Technical Service Bulletin: TSB110149

Rocker Lever Changes (T1106)

This document introduces changes to the QSK19/45/60 rocker levers.

Fig. 1, Rivet

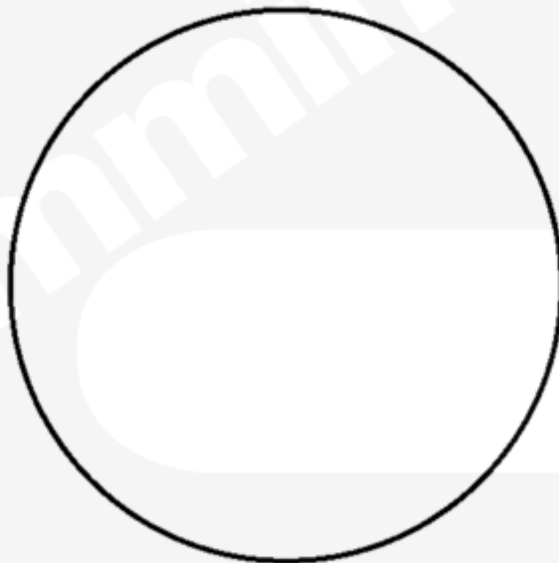
The intake and exhaust rocker levers have used rivets, Part Number 208084, to seal the oil drilling since the beginning of the Quantum™ program. As reports from the field came in, the rocker lever oil drilling diameter was changed in June 2000 (for the QSK19) and July 2000 (for the QSK45 and QSK60) to accept pressed-in steel balls, Part Number 3067941, as the short-term fix.

The following table lists each rocker lever part number, along with the original (production) oil drilling sealing mechanism, approximate engine serial number range, and service sealing replacement mechanism part number. The ball plug, Part Number 3067941, should be used to replace any failed rivet or ball plug. The drive plug, Part Number 4065627, should be used to replace a failed drive plug.

Fig. 2, Ball Plug

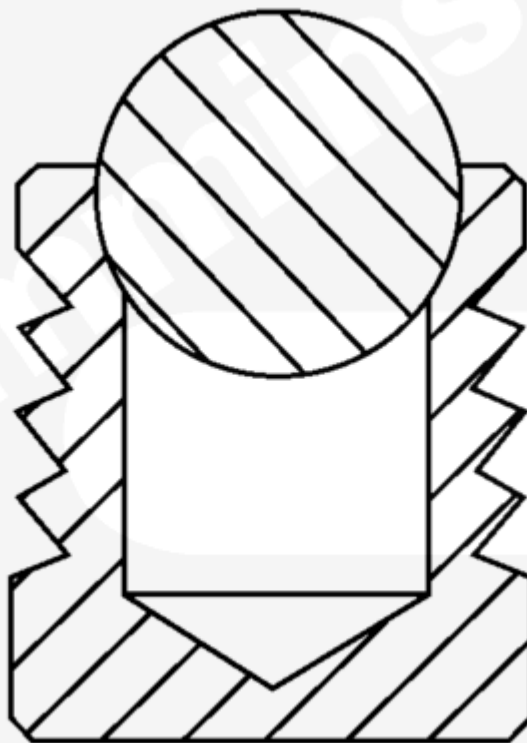
The injector rocker levers have used pressed-in steel balls to seal the oil drilling since the beginning of the Quantum™ program. The move from the steel balls, Part Number 3067941, to the drive plug, Part Number 4065627, sealing mechanism was made at the same time as the intake and exhaust rocker lever changes for the QSK19.
